ADDENDUM NO. 1

Reference: Partial Remodel – Administration Building 002
Redwood Road Campus – Salt Lake Community College
DFCM Project No. 07324660

addendum

ELECTRICAL ADDENDUM #01

MAIN LEVEL ELECTRICAL DEMOLITION PLAN - AREAS 1B & 2A
SCALE: 1/8"=1'-0"

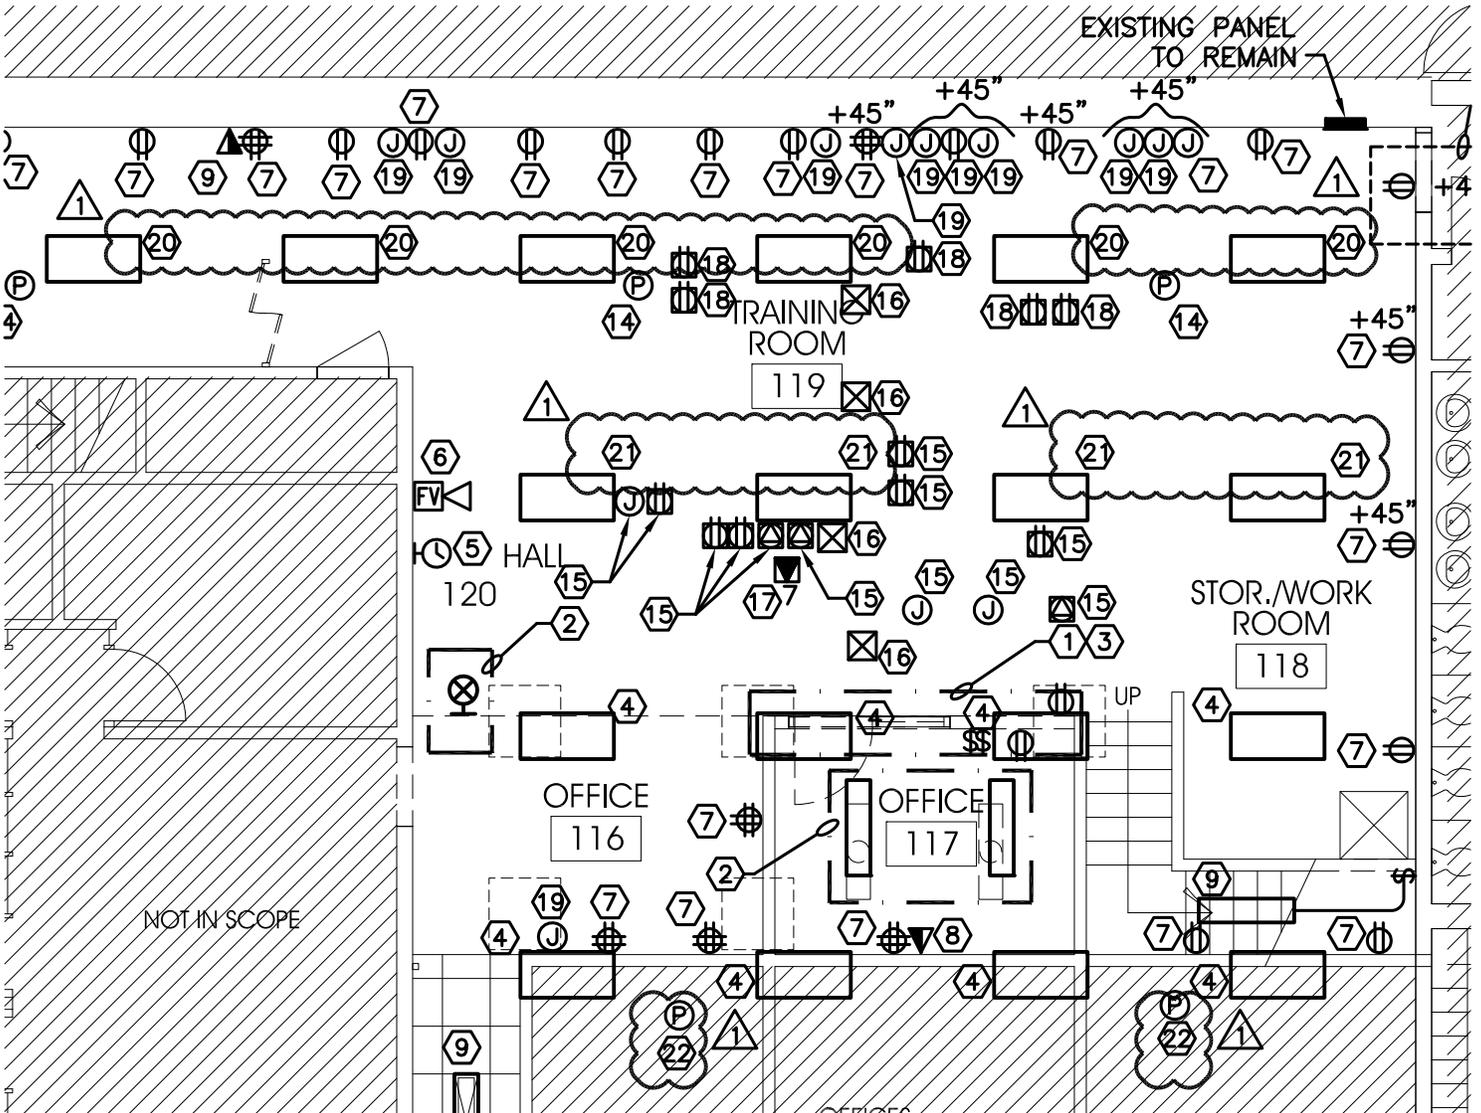
4. Sheet ED102
 - 4.1. Revise: Revise the keyed notes, lighting demolition and fire alarm notes as indicated in the attached drawing ADD1-E1.
5. Sheet EP102

- 14. EXISTING FIRE ALARM DEVICE TO BE CAREFULLY REMOVED FROM CEILING AND RE-INSTALLED AT CEILING DECK JUST ABOVE EXISTING LOCATION.
- 20. DEMOLISH LIGHT FIXTURE, CONDUIT AND WIRE BACK TO ORIGINATING PANEL IF POSSIBLE. EXTEND CONDUIT AND WIRING AS REQUIRED TO MAINTAIN ANY CIRCUITS OR DEVICES WHICH ARE TO REMAIN.
- 21. CAREFULLY REMOVE AND SALVAGE EXISTING LIGHT FIXTURE, STORE AND PROTECT FOR RE-INSTALLATION. CONDUIT AND WIRE TO BE DEMOLISHED.
- 22. EXISTING DETECTOR TO REMAIN.

MAIN LEVEL ELECTRICAL LIGHTING PLAN - AREAS 1B & 2A
 SCALE: 1/8"=1'-0"

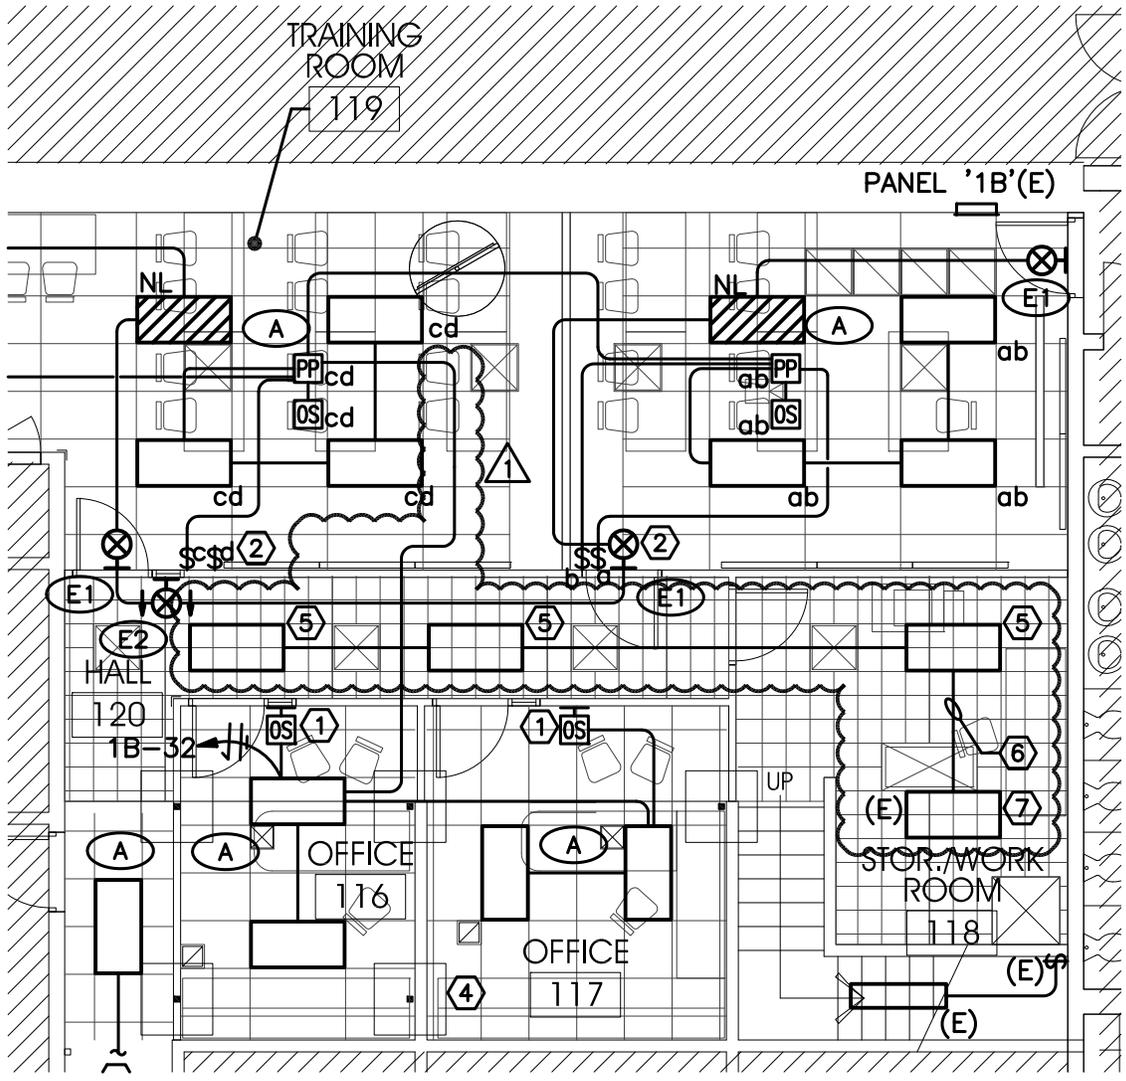
6. Sheet EL102
 - 6.1. Revise: The keyed notes and lighting for the hallway 120 and storage/work room 118 as indicated in the attached drawing ADD1-E2.
7. Sheet EX501

5. RE-INSTALL EXISTING SALVAGED SURFACE WRAP-AROUND LIGHT FIXTURE. PROVIDE NEW CONDUIT AND WIRE. RE-LAMP AND CLEAN FIXTURE.
- ① 6. TIE RE-INSTALLED SALVAGED LIGHTS INTO EXISTING LIGHTING CIRCUIT AND CONTROL FOR MEZZANINE LEVEL.
7. EXISTING MEZZANINE LEVEL LIGHT TO REMAIN, CONNECT RE-INSTALLED SALVAGED LIGHTS HERE.

INDOOR MULTI-ZONE AIR HANDLING UNIT SCHEDULE

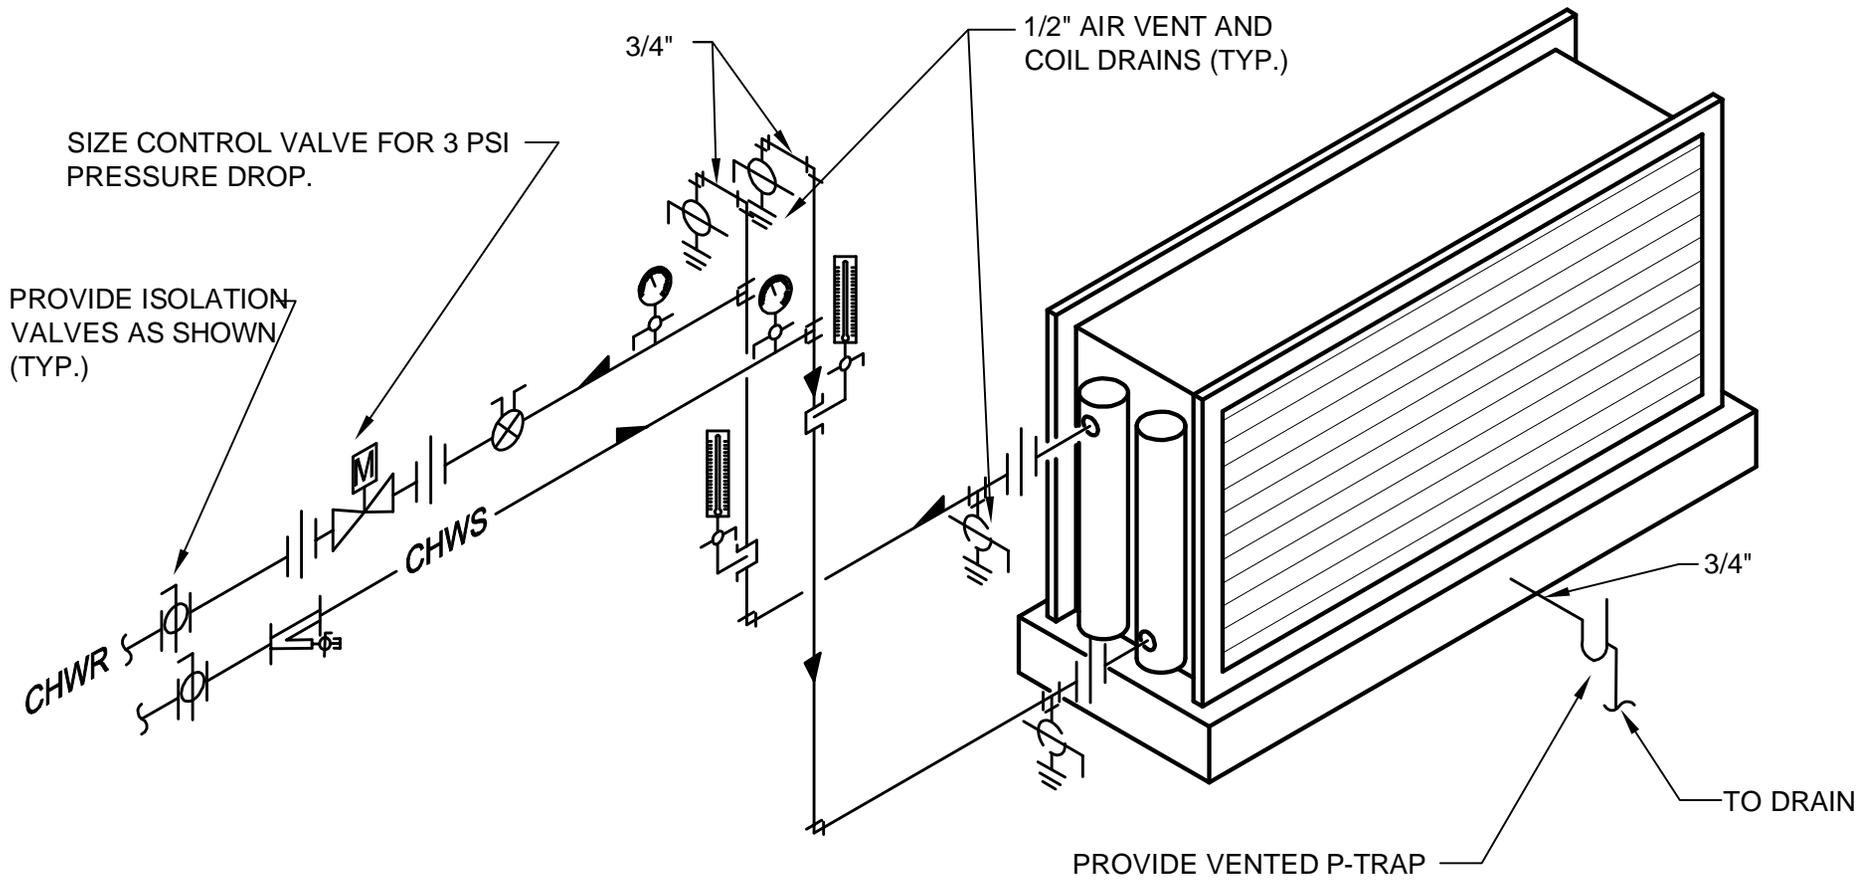
- Item III-4.** Sheet ME105 note 1: Multi-zone 6 is no longer shown on this page. This note shall apply to unit MZ-6 shown on sheet ME502.
- Item III-5.** Sheet ME601: New multi-zone unit MZ-2-6-1 shall have a steam heating coil. See

attached sheet for updated schedule. New coils shall be re-connected to existing chilled water and existing steam piping, and piped per details. See ME501 for steam piping detail. See attached sheet for chilled water piping detail.
